Product / Process Change Notification (PCN)																
<input type="checkbox"/> Major Change <input checked="" type="checkbox"/> Minor Change																
PCN Number: PCN_IndXHMA_20250228 Affected Series: WE-XHMA Affected Order Codes: Please refer to table 1 PCN Date: 2024-08-28 (YYYY-MM-DD) Effective Date: 2025-02-28 (YYYY-MM-DD)	Change Category: <input type="checkbox"/> Equipment/Location <input type="checkbox"/> General Data <input type="checkbox"/> Material <input type="checkbox"/> Process <input type="checkbox"/> Product Design <input checked="" type="checkbox"/> Shipping/Packaging <input type="checkbox"/> Supplier <input type="checkbox"/> Software															
Contact: Product Management Phone: +49 (0) 7942 - 945 5001 Fax: +49 (0) 7942 - 945 5179 E-Mail: pcn.eisos@we-online.com	Datasheet Change: <input checked="" type="checkbox"/> Yes <input type="checkbox"/> No Attachment: <input type="checkbox"/> Yes <input checked="" type="checkbox"/> No

Table 2. Packaging Changes of affected Order Codes

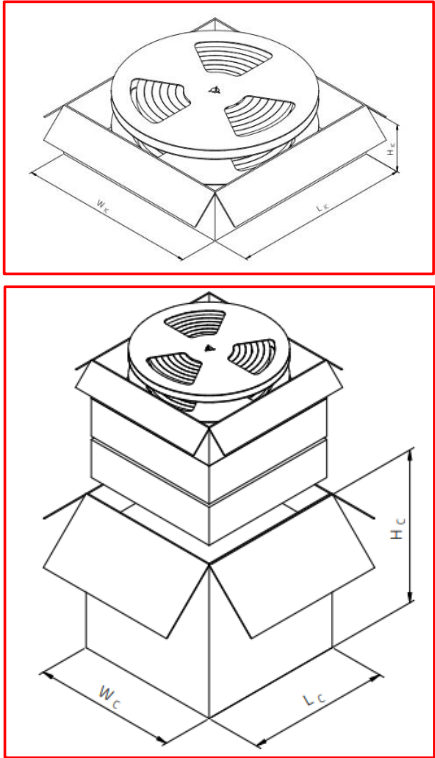
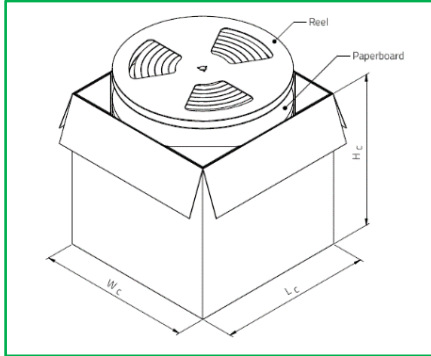
1. To reduce the amount of packaging waste in the product series WE-XHMA, with sizes and order codes indicated in table 1, the inner boxes will be omitted. No plastic filler will be used, and every reel will be stacked and separated by paperboard. The outer box dimension, reel quantity (pcs.), and box quantity (pcs.) will be updated accordingly. Additional details of the changes can be found in the table below:
